# Work Order ID 94872

Item Name: Crosstube Assembly, Mid Aft

DRAWING NO. D206-667-247	TITLE CROSSTUBE ASS'Y (206L MID AFT)	REV. A	<b>DART AEROSPACE LTD ENGINEERING ORDER</b>		D.E.O. NO. D206-667-247-A-1	SHEET NO. SHEET 1 OF 1	SCALE NTS
DRAWN 9P	CHECKED ASS	MFG. APPR. KDB	APPROVED JMP		DE APPR. H		
DATE 11.07.15	DATE 11.07.20	DATE 11.07.21	DATE 11/07/21		DATE 11.07.21

**PURPOSE:**

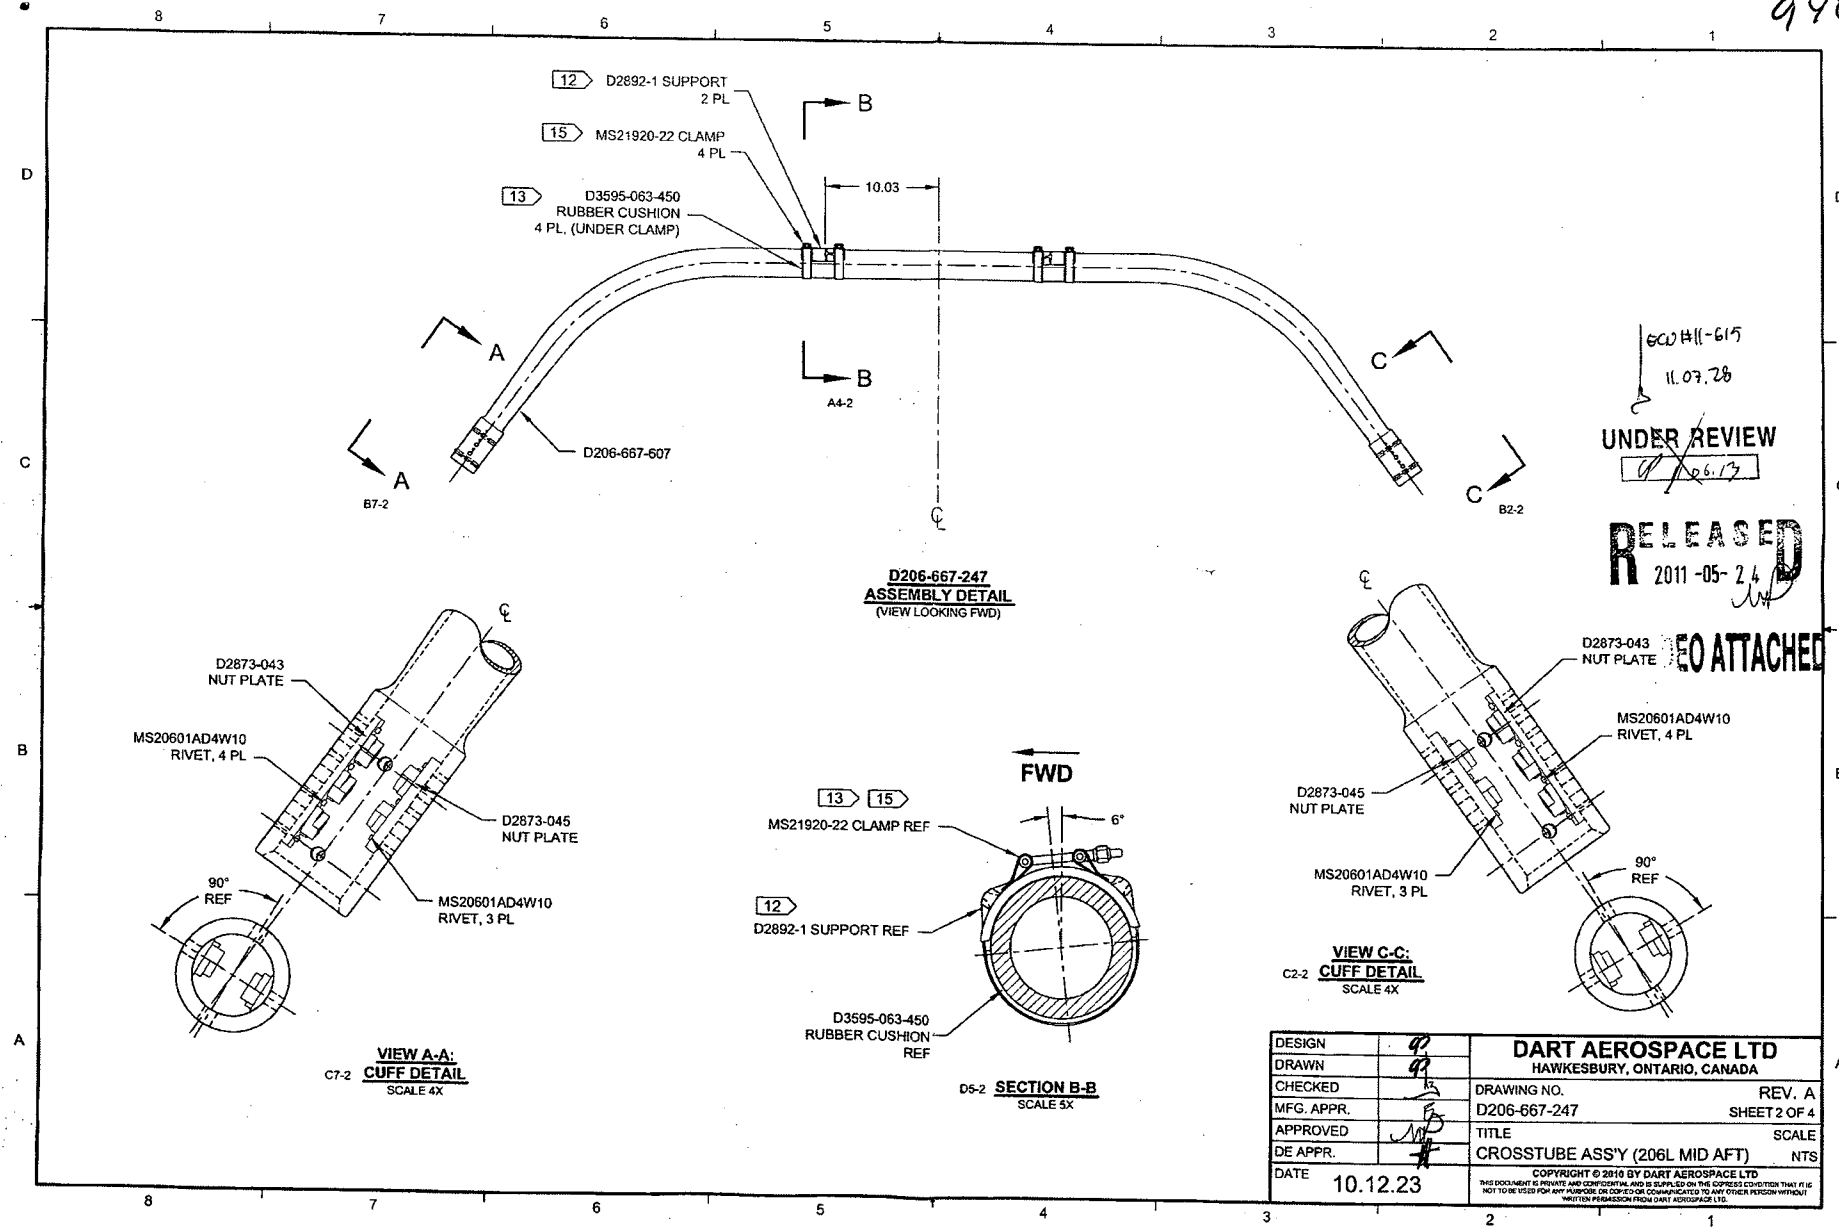
REPLACE MAGNOBOND WITH PROSEAL.

NOTE 12 &amp; 15, SHEET 1 IS AMENDED AS FOLLOWS:

Item	Qty -247	Part Number	Description
9	A/R	PROSEAL 890 B-2	SEALANT, AMS-S-8802 CLASS B-2

- 12) TO INSTALL D2892-1 SUPPORT: ABRASE MATING SURFACE OF SUPPORT AND CROSSTUBE WITH 180-GRIT SANDPAPER AND REMOVE RESIDUE WITH MEK (OR EQUIVALENT). APPLY A 0.04" TO 0.07" THICK LAYER OF PROSEAL 890 CLASS B-2 (OR AMS-S-8802 CLASS B-2) SEALANT TO MATING SURFACE OF SUPPORT.
- 15) TORQUE CLAMPS 80 TO 100 IN.-LB. ENSURE AT LEAST 1.5 THREADS SHOWING IN SAFETY AND THAT NUT HAS NOT BOTTOMED-OUT AFTER TORQUING. **PRIOR TO PACKAGING, RE-CHECK TORQUE ON CLAMPS AFTER PROSEAL 890 SEALANT HAS CURED FOR 72 HOURS.**
